ADDENDUM NO. 2
SEWER SYSTEM IMPROVEMENTS
CONTRACT 15-01
CARTER'S CREEK SEWAGE PUMPING STATION RENOVATION
COLUMBIA, TENNESSEE
JRWCO JOB NO. 2039

Date of Addendum: Tuesday, December 15, 2015
Bid Opening: Thursday, December 17, 2015, 2:00 P.M. Local Time

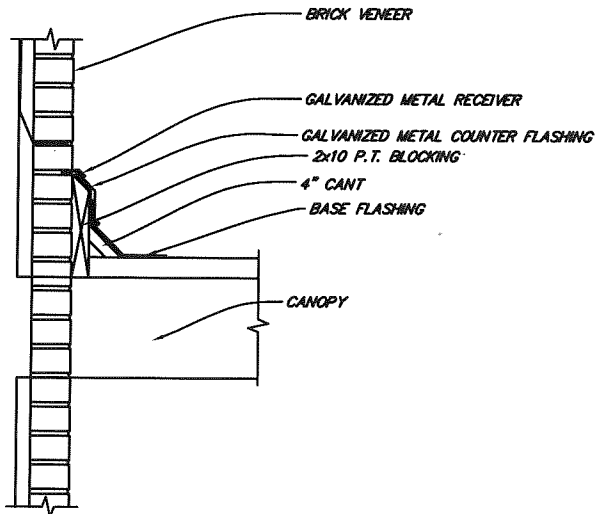
6. Plans, Sheet 2:

Modify as shown on the attached 8 ½" x 11" sheet.

△ 7. THE CONTRACTOR SHALL REMOVE ALL EXISTING INSULATION FROM PIPING AND DUCT WORK AND REMOVE ALL RESIDUE.

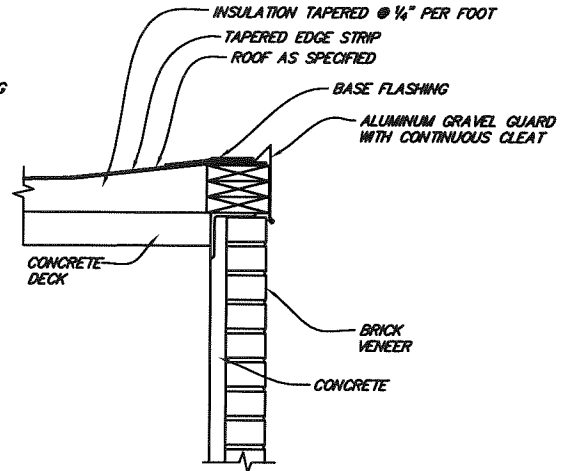
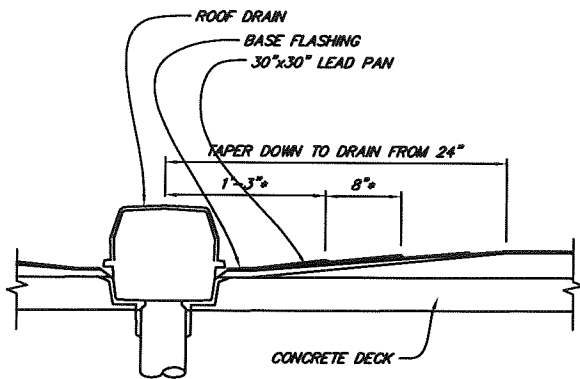
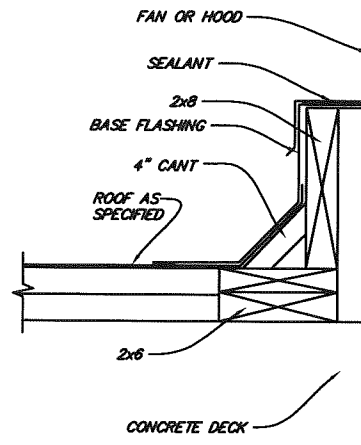
8. Plans, Sheet 4:

Modify as shown on the attached 8 ½" x 11" sheet.
